General response authors

A three-dimensional palaeohydrogeological reconstruction of the groundwater salinity distribution in the Nile Delta Aquifer

Figure 1: Palaeogeography and groundwater salinity measurements up to 250 m depth of the Nile Delta. Palaeogeographical data from Pennington et al. (2017). The inset shows the location of the delta in Egypt.

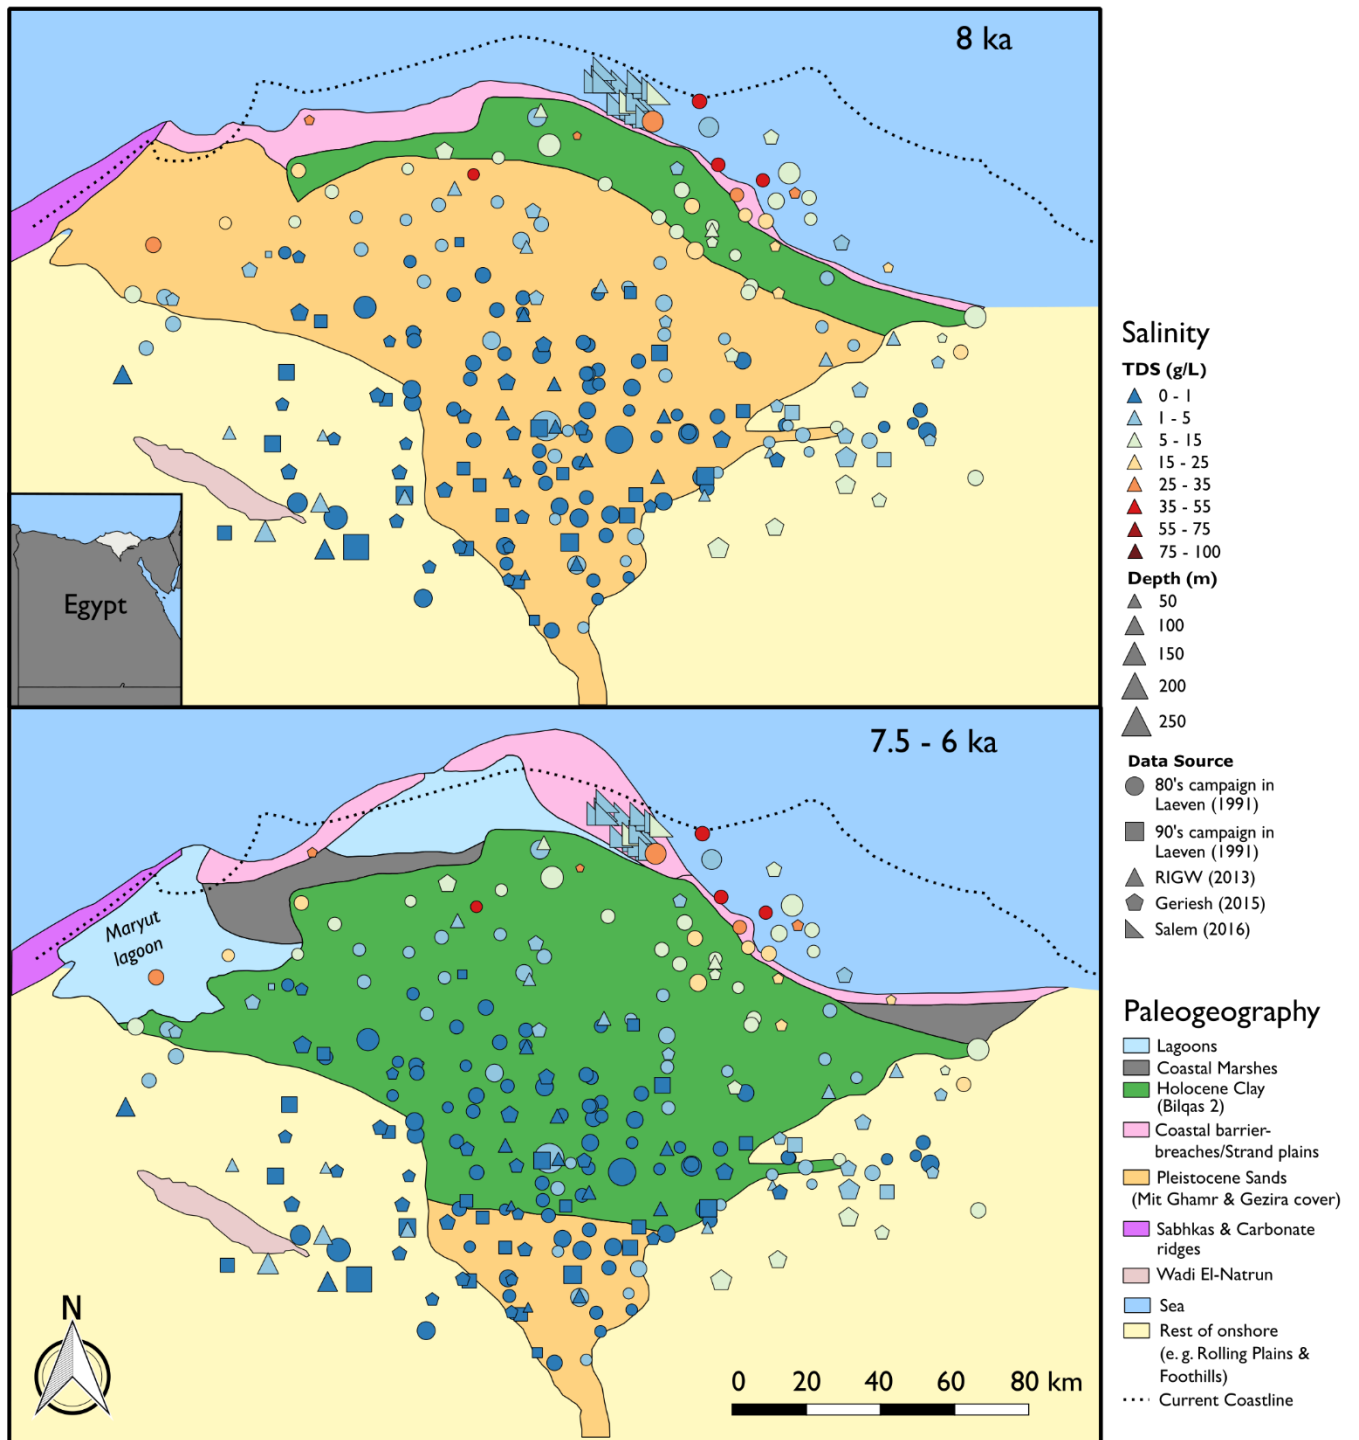
P3L17: “and the extent of this brackish zone coincides with palaeo-shorelines (Stanley and Warne, 1993) (Fig. 1). ”

Why don't you also cite <https://www.cambridge.org/core/journals/netherlands-journal-of-geosciences/article/geological-processes-and-the-management-of-groundwater-resources-in-coastal-areas/A62ABC242EA271A6CC2C415E938CCC11/share/999729834d9ef57f3a76c3624b5d1f7c242a847c>

We have added this reference **[P3L19-P3L20]**:

and the extent of this brackish zone coincides with palaeo-shorelines (Kooi and Groen, 2003; Stanley and Warne, 1993) (Fig. 1)

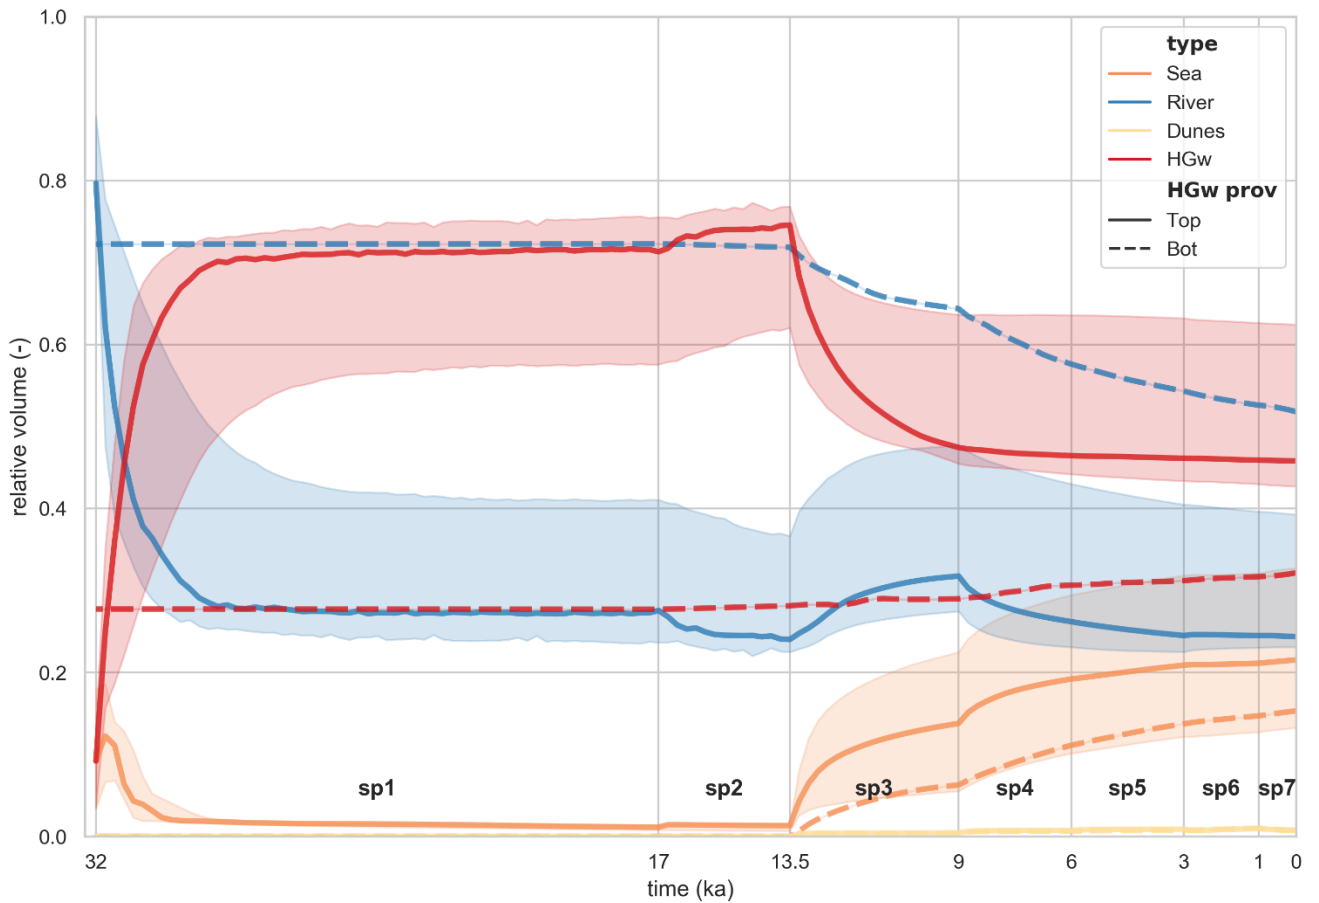
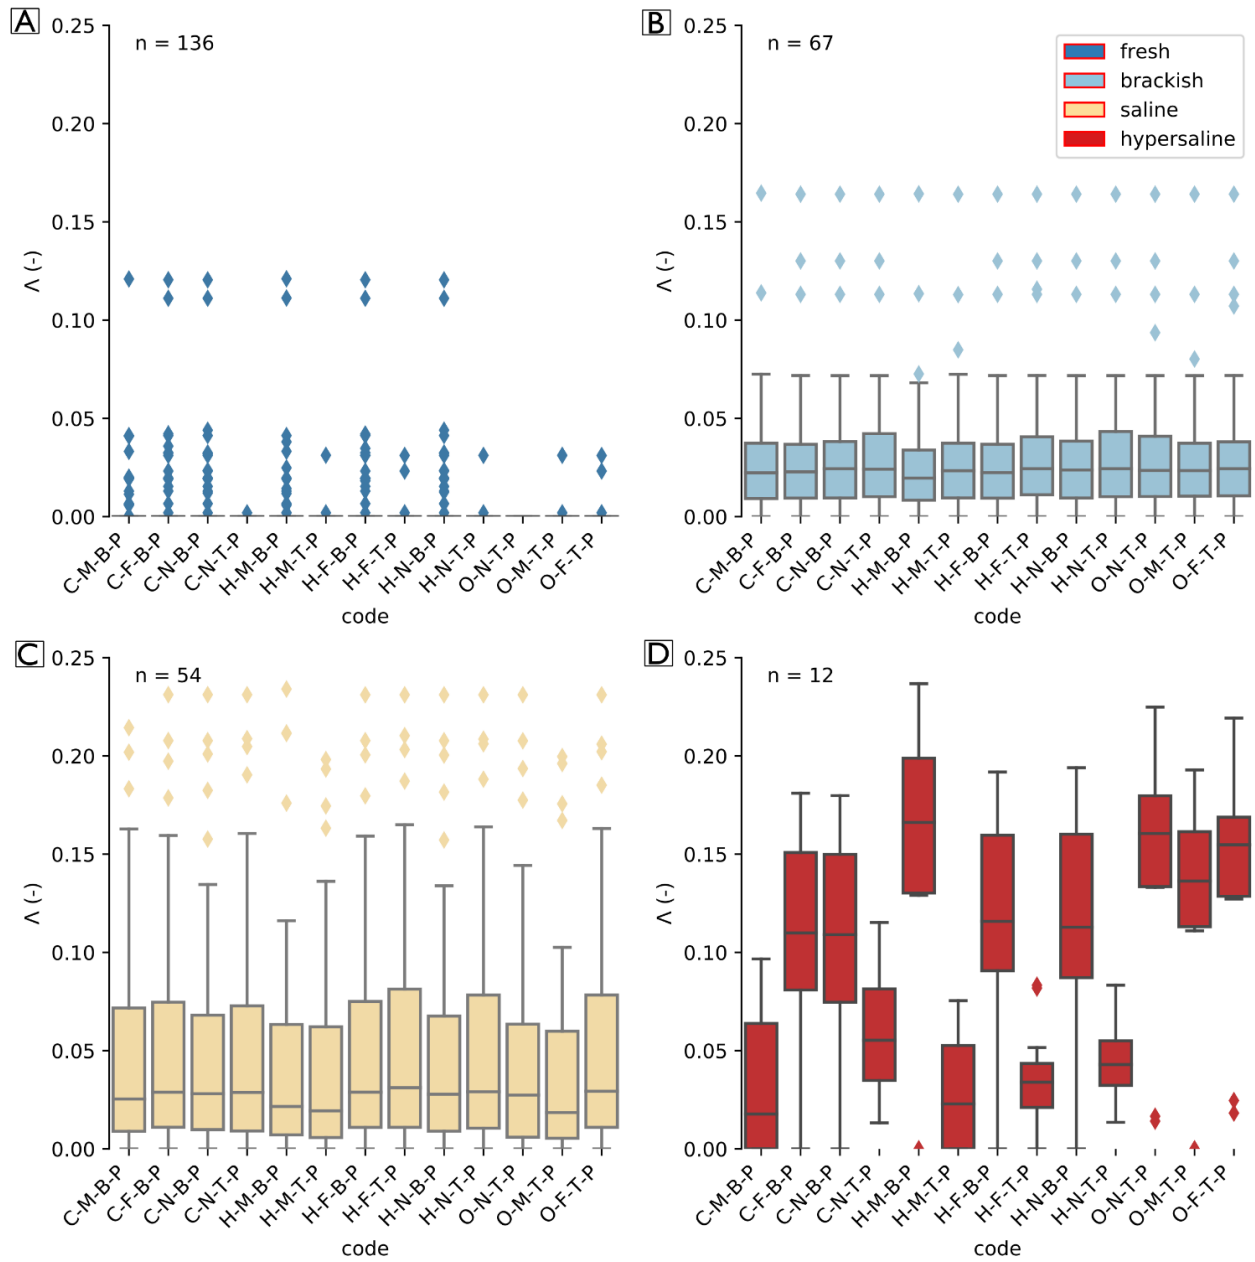
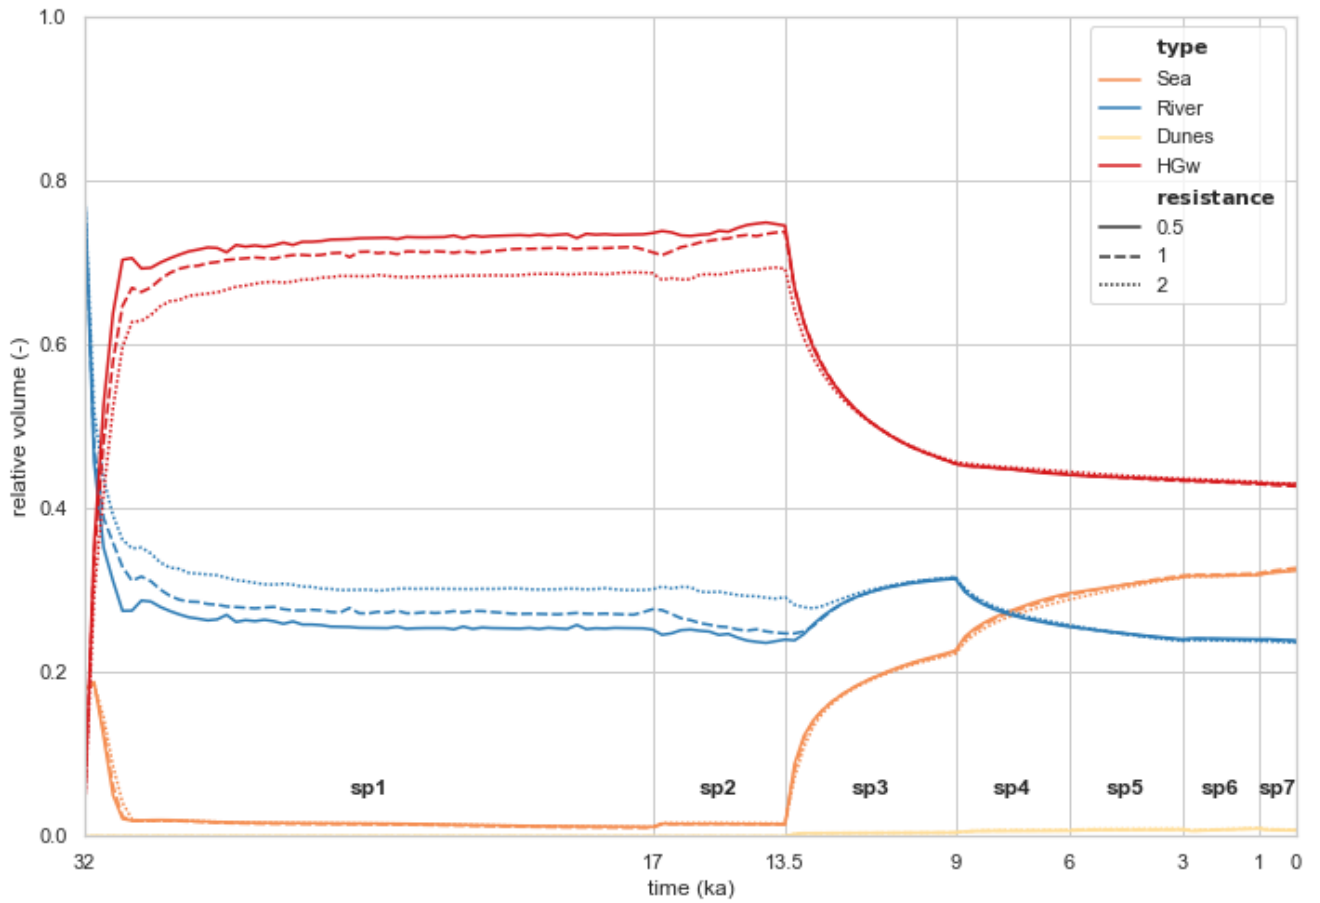
P7L23: “A time slice is also known as “stress period” by groundwater modellers (Harbaugh, Arlen, 2005).”

I really don't see the need to introduce a new term from something that is well understood within the scientific community. It only creates confusion in our terminology.

OK, we have changed this throughout the paper and updated figures 5, 7, and B1.

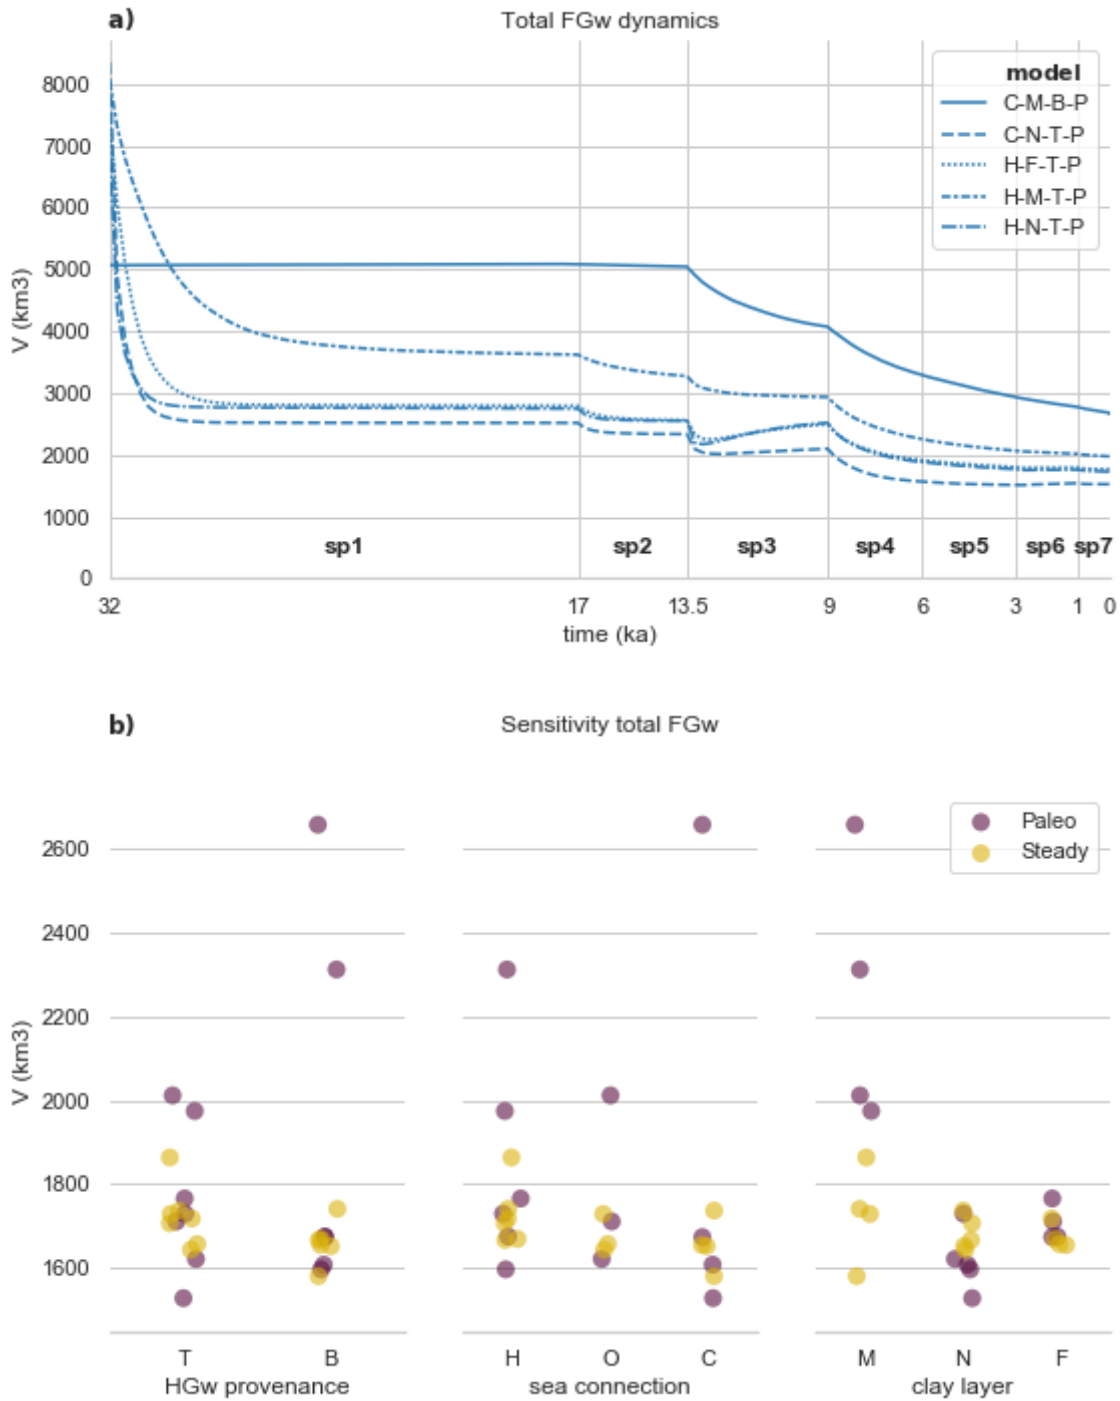
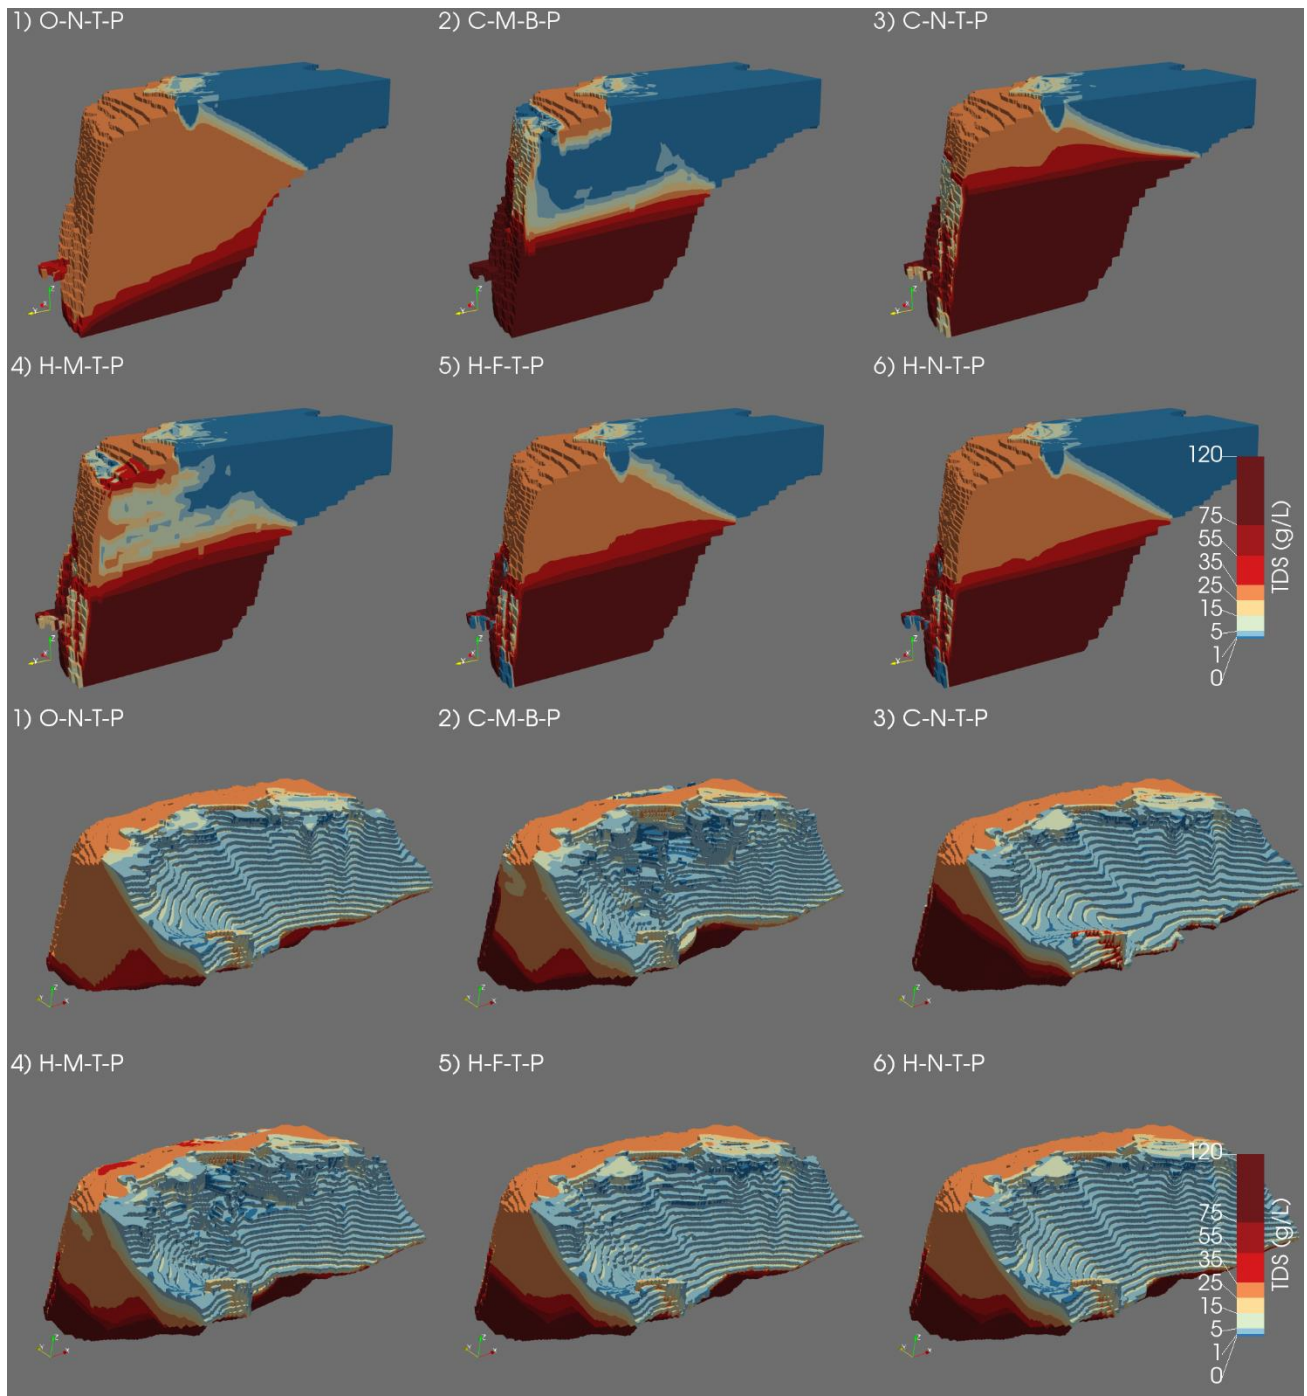
I wonder why H-F-T-P and H-N-T-P have such similar salinity distributions and freshwater volumes, even though the fluvial clays have a much lower conductivity than sand.

The differences are indeed not very noticeable, the H-F-T-P model does respond a bit slower which can be seen in the first stress period in the fresh water volumes (Fig 7a) and furthermore its salinity distributions are more chaotic (Fig 4, bottom). We attribute the only slim differences in the Holocene to the fact that the timescale of the model is large enough to cancel out the slower response caused by the fluvial clays. If the boundary conditions in our model changed more frequently, we think the differences would be more pronounced than they are now.

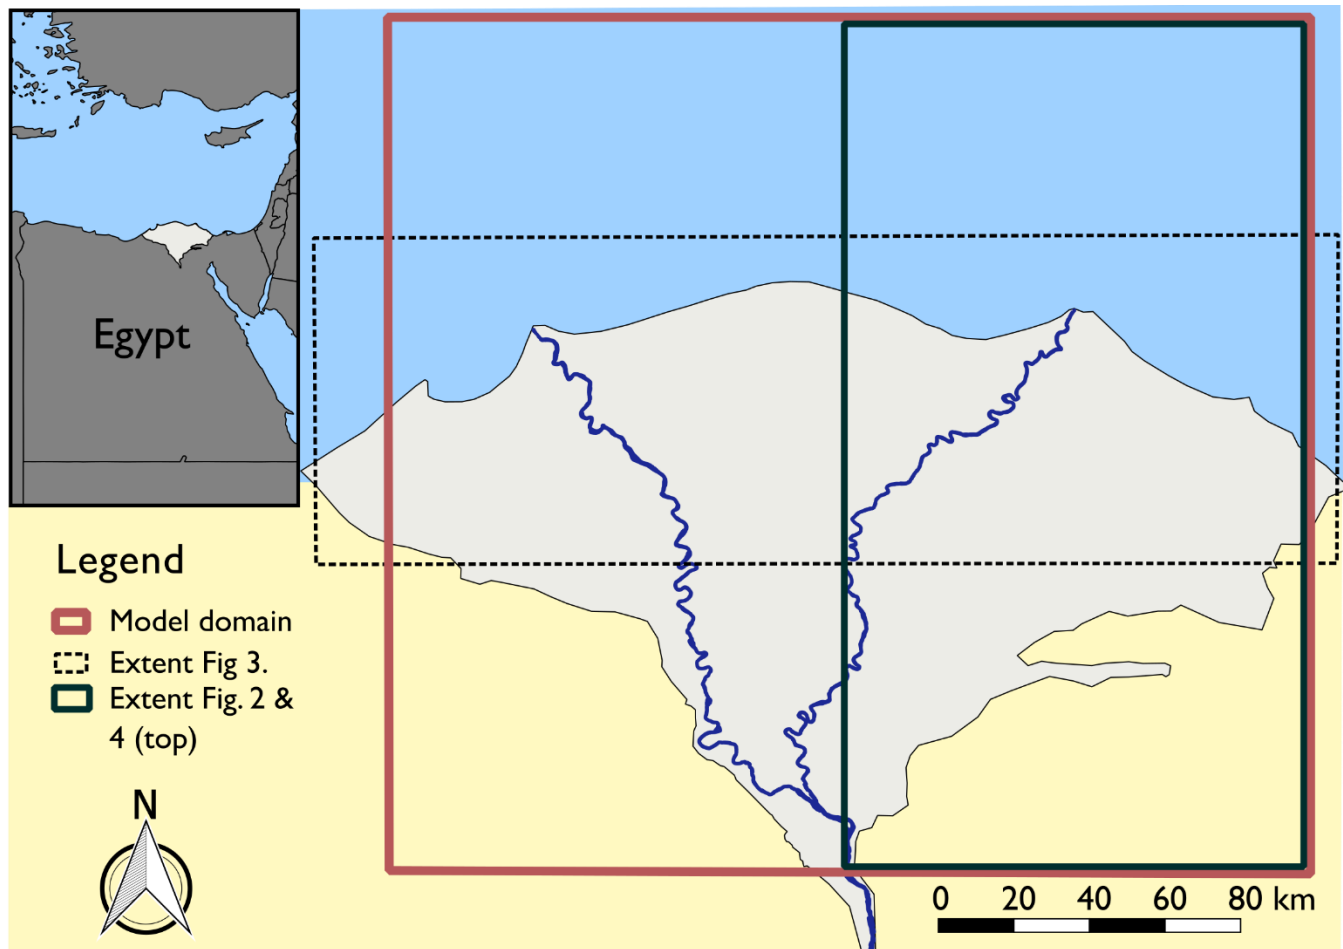
P15L19: “since only the zone above 250 m depth has been sampled”

It is hard to follow your argumentation here. It sounds as if the freshening has something to do with the steady-state interface.

We have added a sentence with clarification here [P16L23-P16L24]:

... since only the zone above 250 m depth has been sampled. This is the zone that we expect to slowly freshen from our comparison between palaeohydrogeological and steady-state models (Fig. 9).
